## **Cabling Specifications for:**

### **New Administration Building Cabling RFP P-70-17/18**

The information below either addresses specifications NOT covered in Network Cabling Global Specification document or addresses questions raised at bids conference and/or building walk-thru:

## Patch panel labeling standard

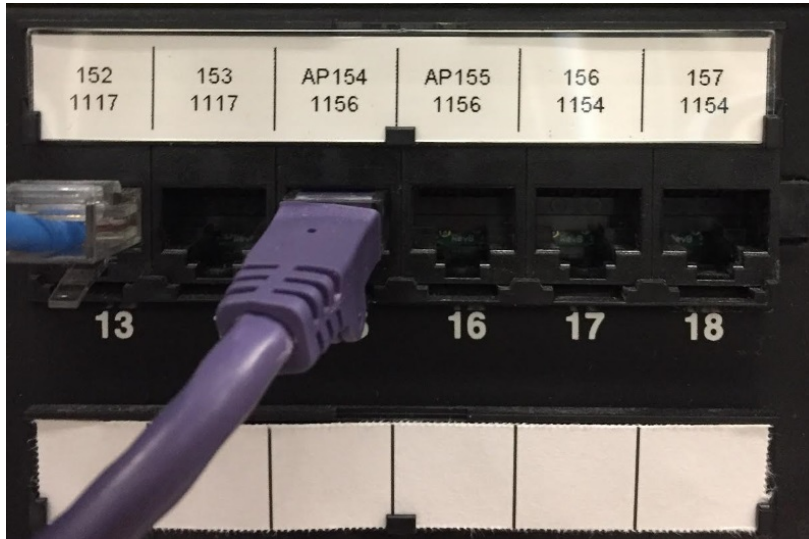
1. When multiple patch panels are installed at the MDF/IDF, port numbering needs to be **continuous** (i.e. Panel 1: 1-48, Panel 2: 49-96, etc.)
2. MDF/IDF patch panel label: [Port#] / [Room#] i.e. 153 / 1117. Ports used for wireless access points (WAPs) need to include "AP" before the port number i.e. AP154. Use two rows as shown in the picture.
